**DOCUMENT 00 90 00  
ADDENDUM**

**ADDENDUM NO. [1]                      Date: March 13, 2020**

**RE:                      SCHOOL DISTRICT OF HOLMEN  
                             HIGH SCHOOL ADDITION AND REMODELING PHASE 2  
                             1001 McHUGH ROAD  
                             HOLMEN, WISCONSIN 54636  
                             HSR 18061**

**A300**

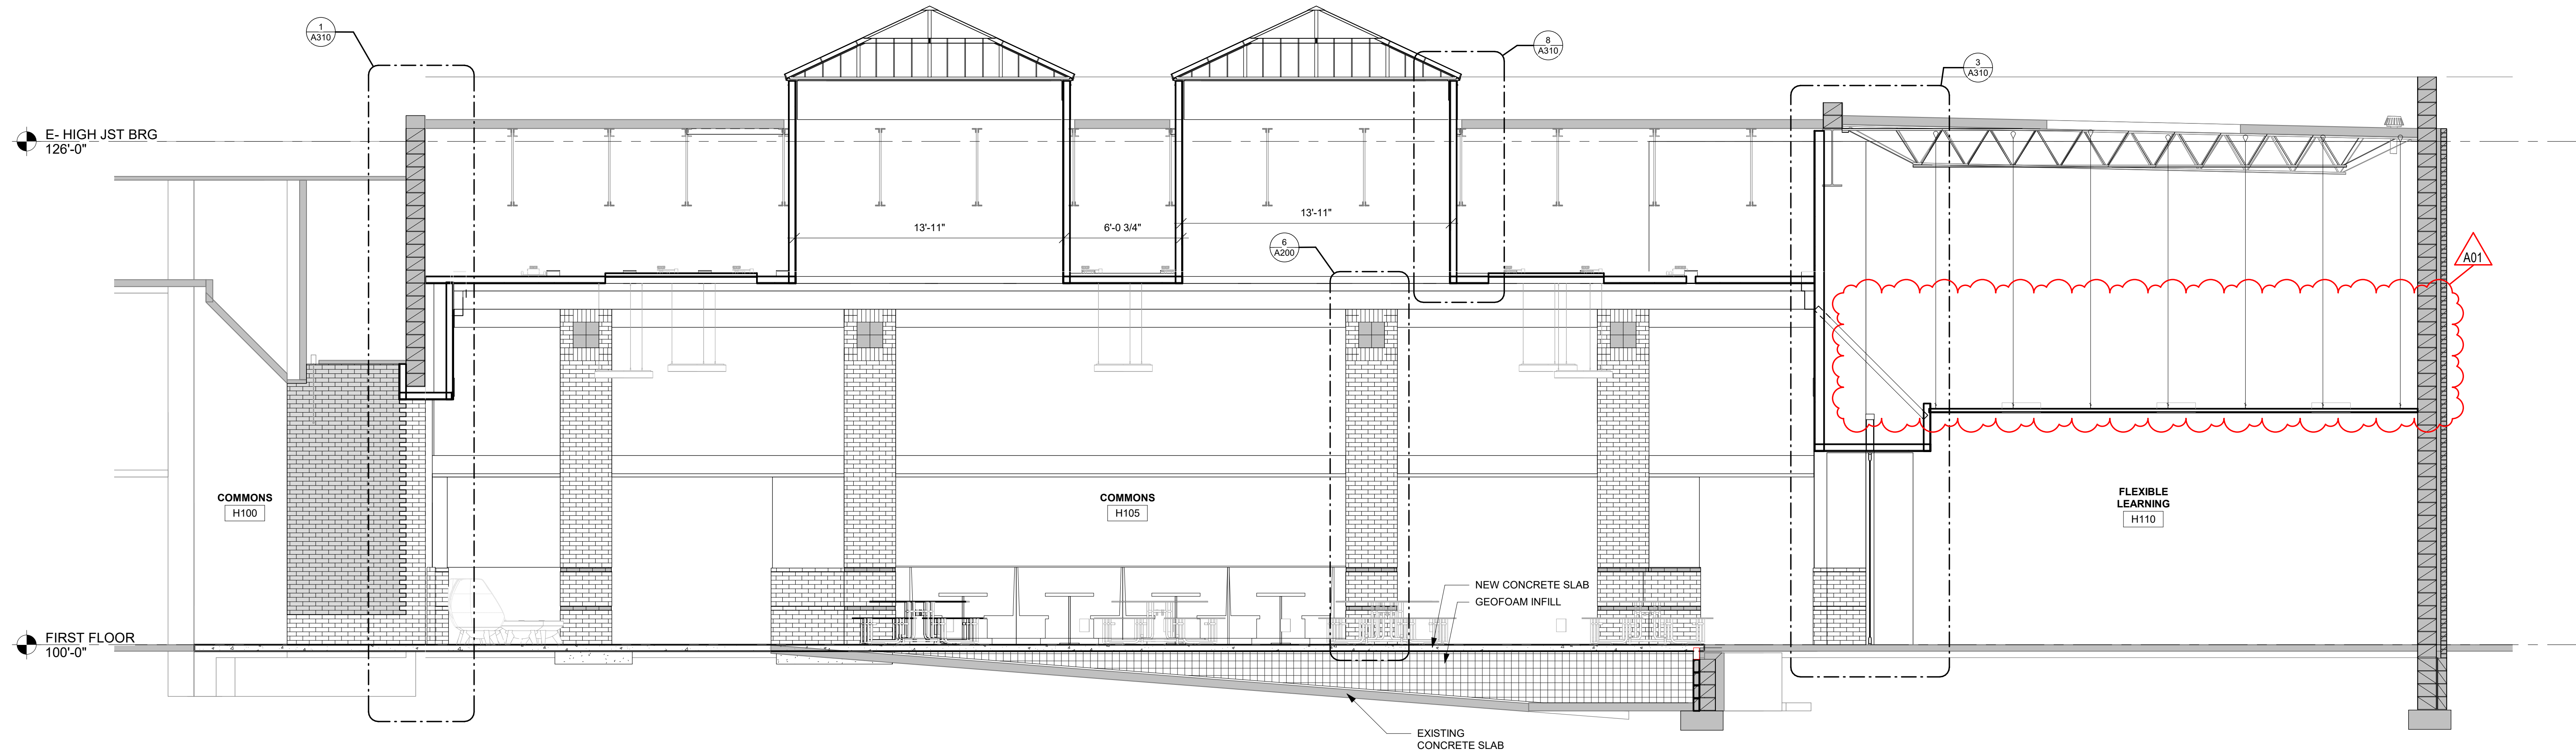
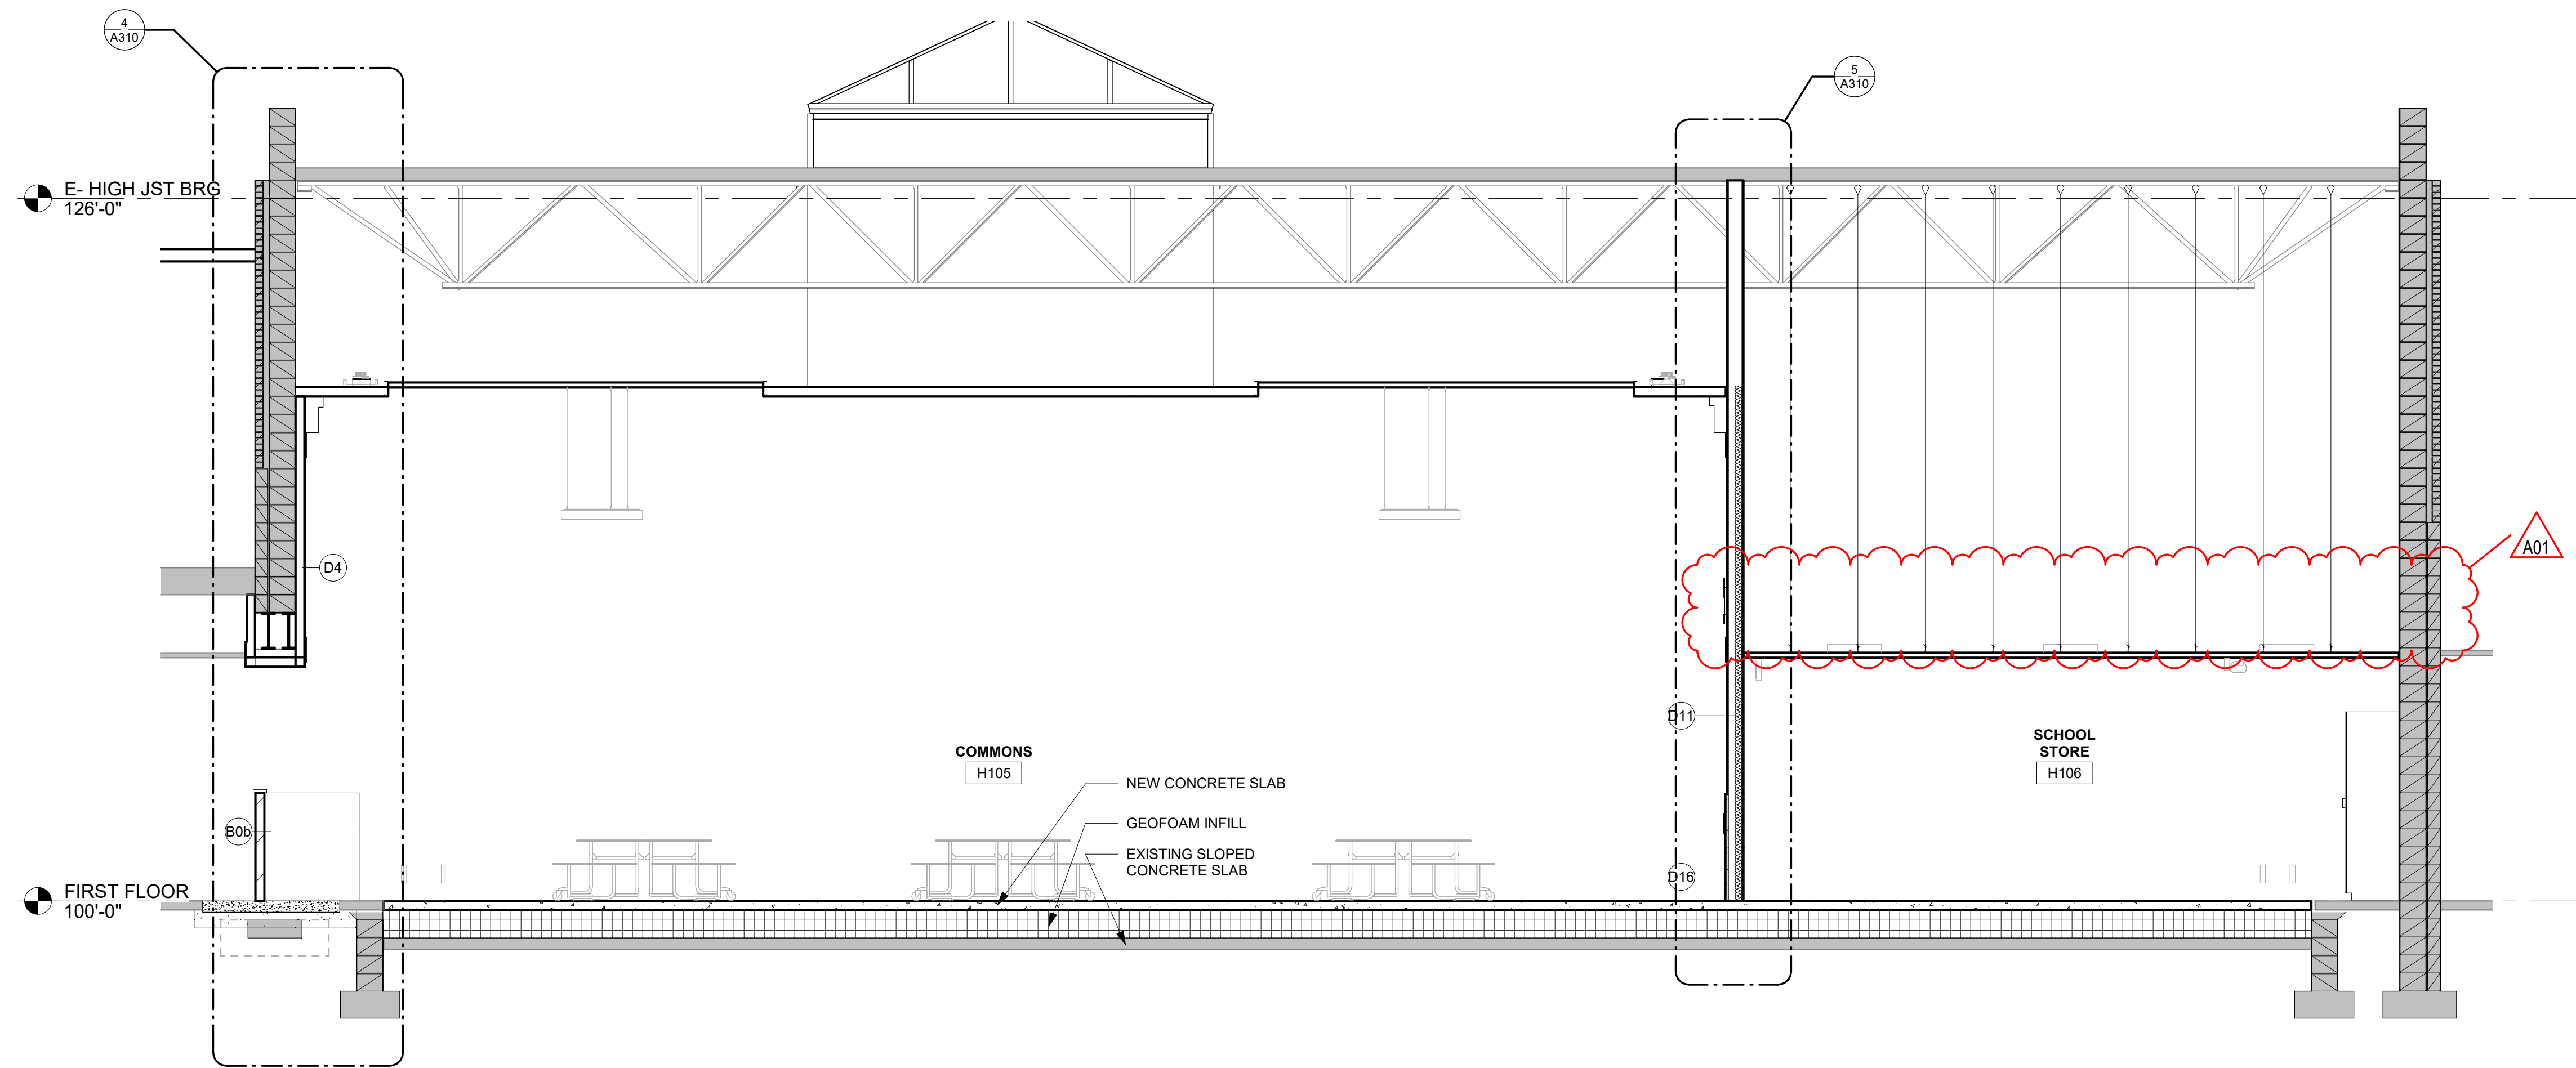
- a. Revisions clouded on Drawing.
- b. 1 & 2 A300; Delete secondary ceiling support. Suspend ceiling from structure above.

**A301**

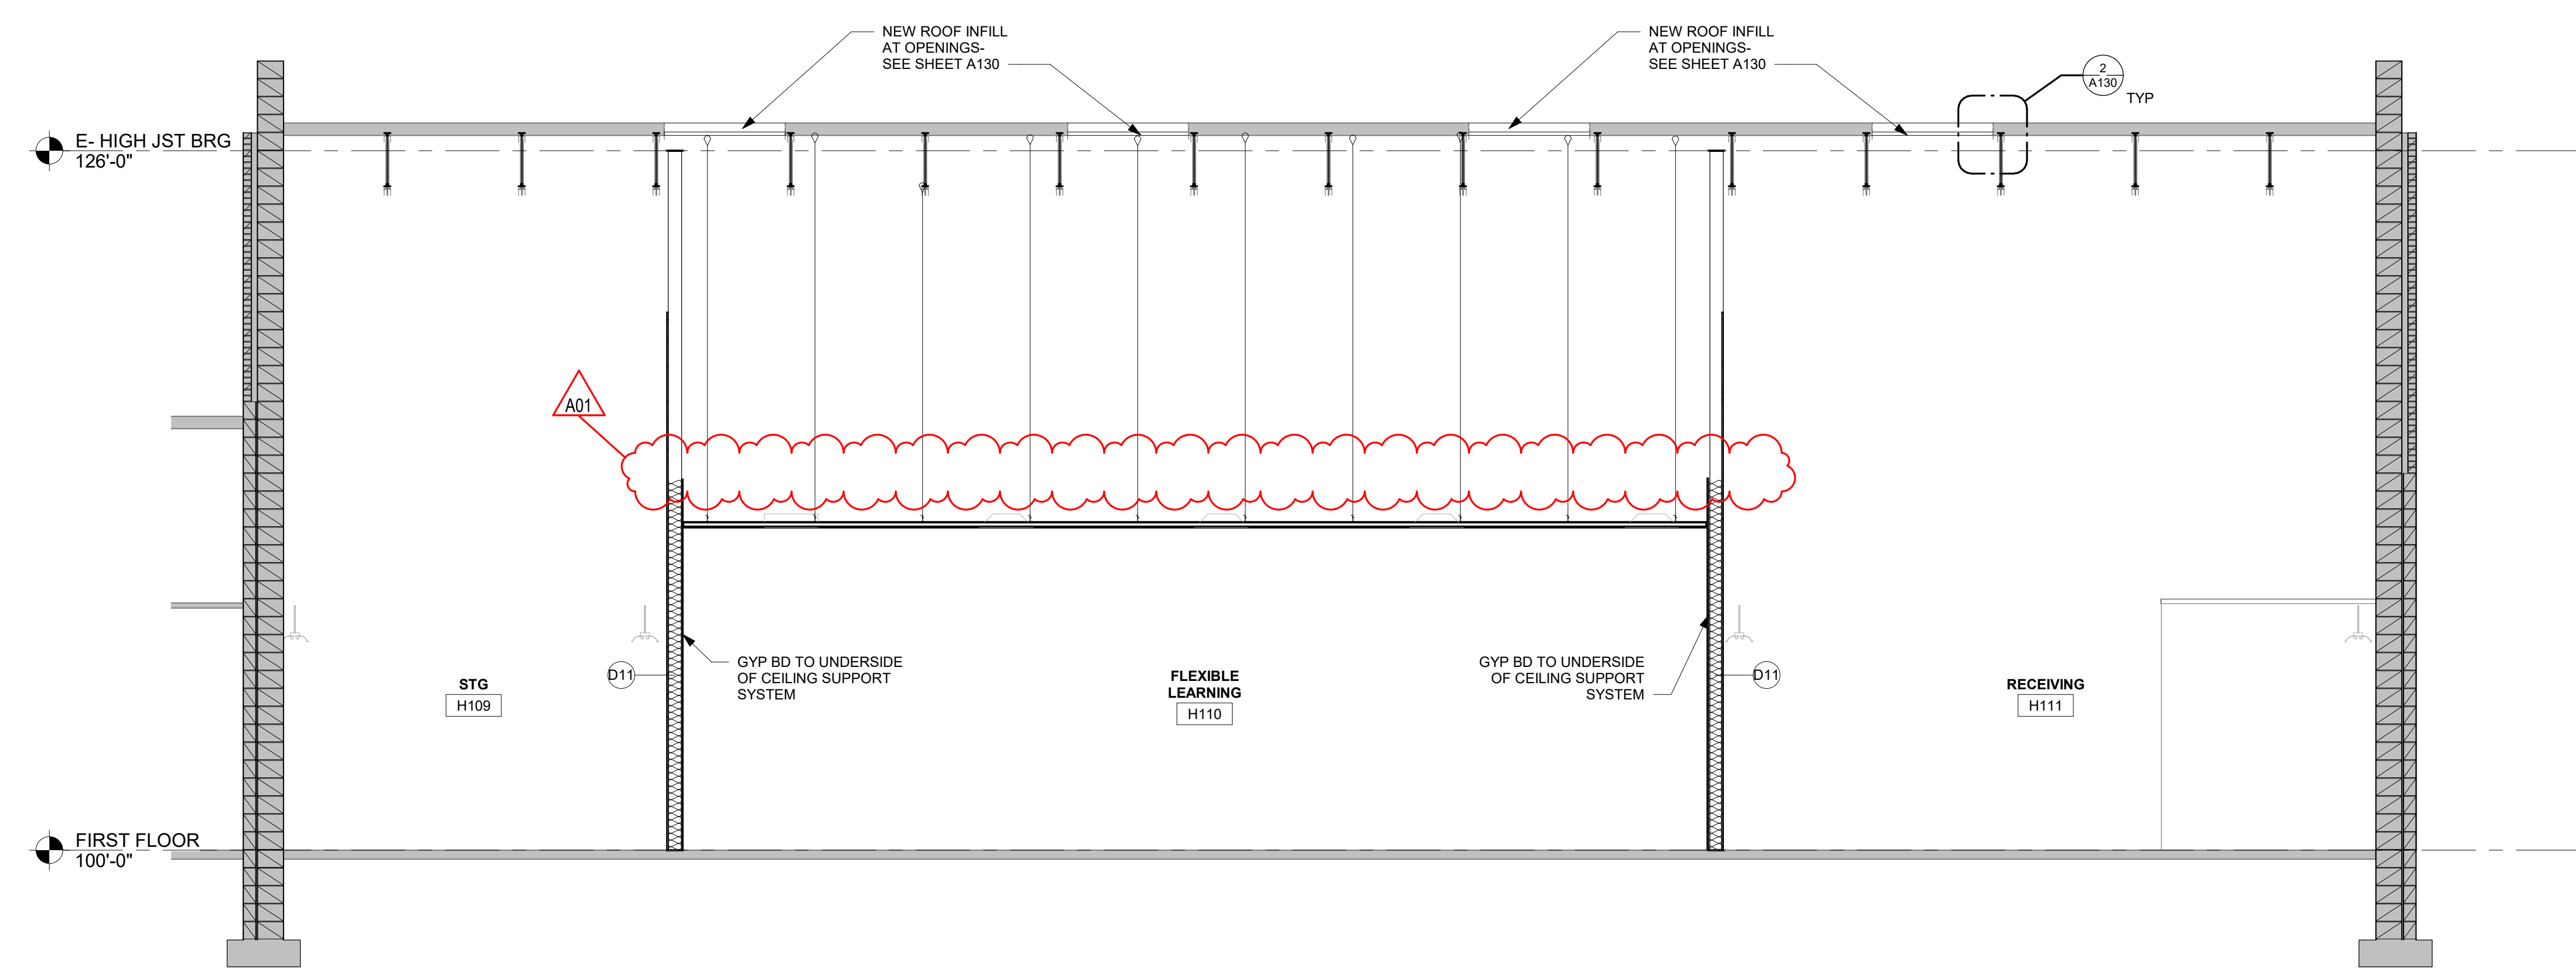
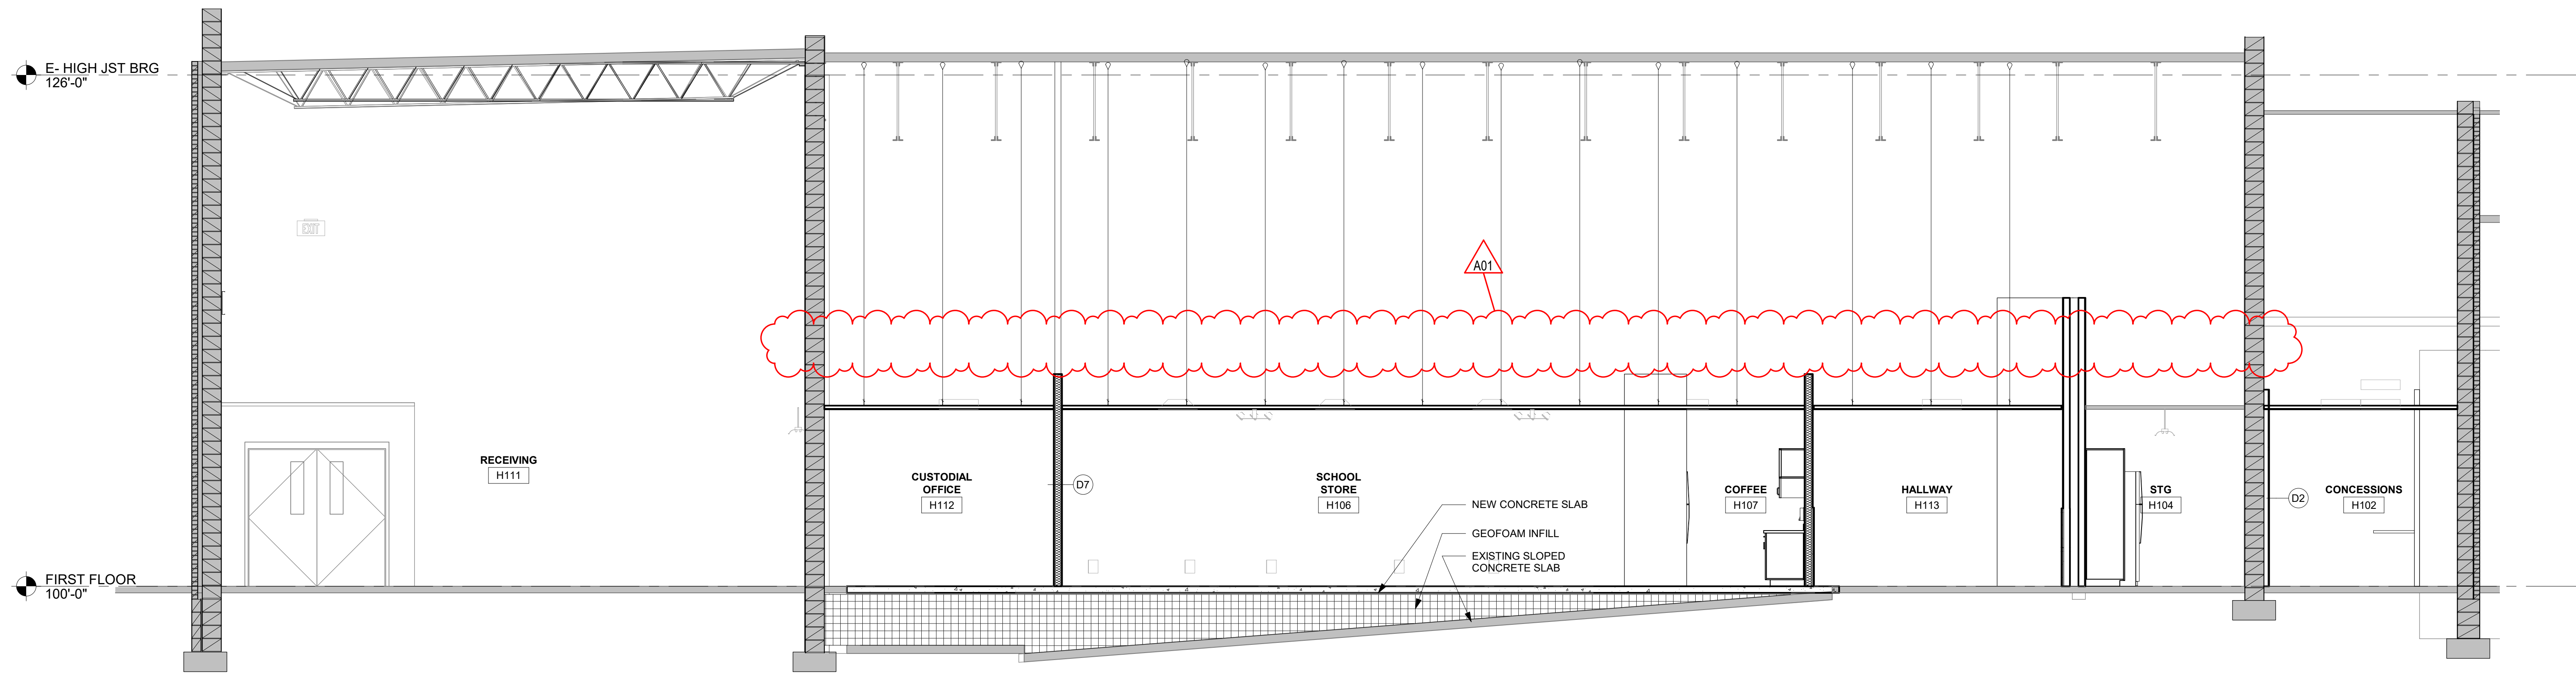
- a. Revisions clouded on Drawing.
- b. At each section, delete secondary ceiling support. Suspend ceiling from structure above.
